STATE OF NORTH CAROLINA  
DEPARTMENT OF TRANSPORTATION

Subject: **Application for Modification to Section 404 Individual Permit and 401 Water Quality Certification** for the widening of Davis Drive (SR 1613/SR 1999) from Morrisville-Carpenter Road in Wake County, State Project No. 9.8051713, WBS Element: 35018.1.1, Division 5, TIP U-4026.

**Permit Site No. 3 (Sheet 11 of 65) at 132+10 Lt -L-  
Construction Issue:**

Site 3  
sheet 11 of 65

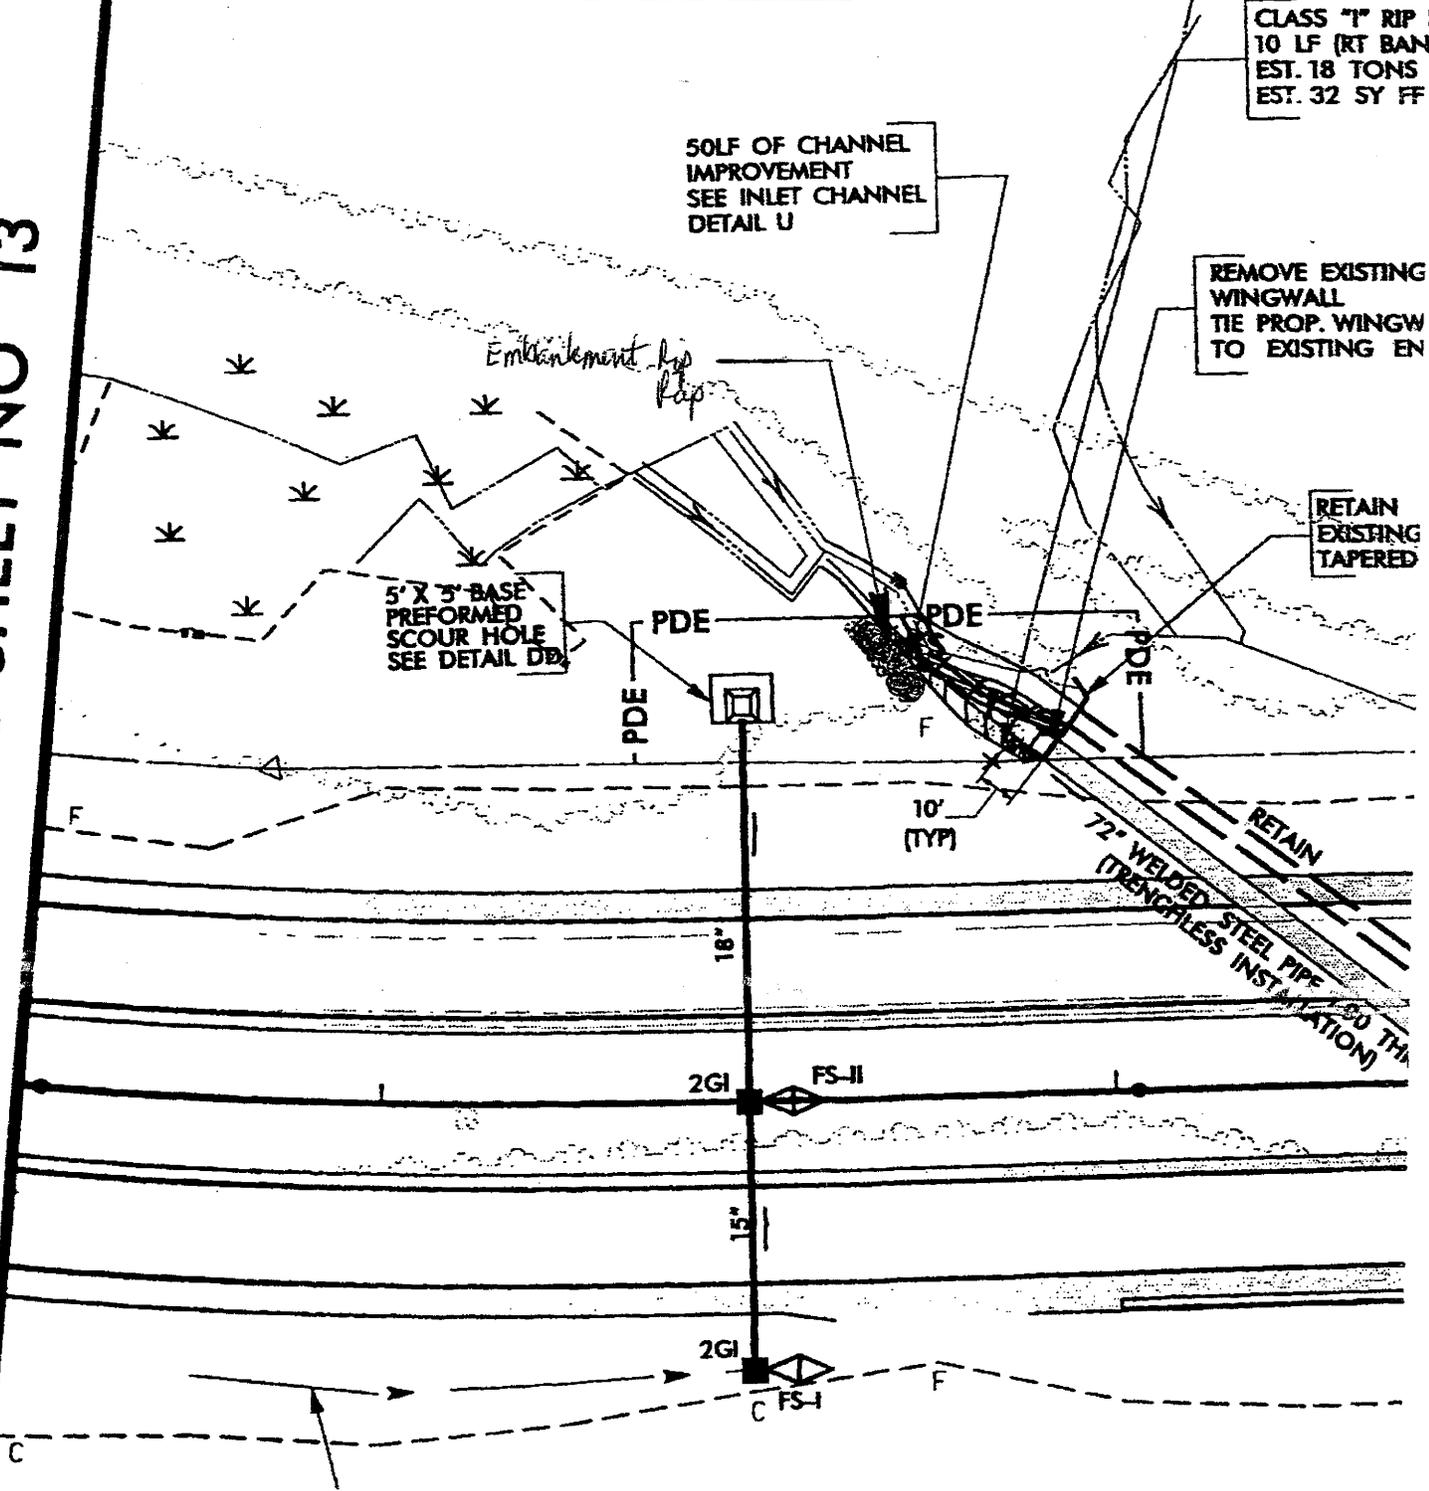
A pre-formed scour hole (PFSH) has been constructed at this location, as indicated in the original permit application. Note that the icon depicting the PFSH is not to scale and construction of the

PFSH per the dimensions provided in Detail DD extends the outer-most edge of the device to the full extent of the PDE.

The stream has shifted slightly since the permit drawings were originally completed and currently extends into the NCDOT right of way; as a result, the outer-most edge of the device is almost directly adjacent to an unnamed tributary to Kit Creek in the Cape Fear Basin (Jordan Lake Watershed). Runoff from the PFSH has caused formation of a scour on the streambank of the unnamed tributary.

NCDOT proposes to place appropriate fill material into the scour and then construct a small, shallow, rip rap-lined swale that would extend from the outer-most berm of the PFSH to below the ordinary high water mark on the adjacent unnamed tributary (see attached sheet). This will require the installation of up to 25 linear feet of Class I rip rap for the purpose of streambank stabilization.

Placement of the rip rap on the streambank below the ordinary high water mark will result in 25 linear feet of permanent stream impacts. The rip rap will not extend across the stream bed, therefore there will not be a loss of stream function. NCDOT does not propose mitigation for these additional impacts. Per the tear sheet modification issued by NCDWQ on December 17, 2009, NCDWQ will not require mitigation for this impact.
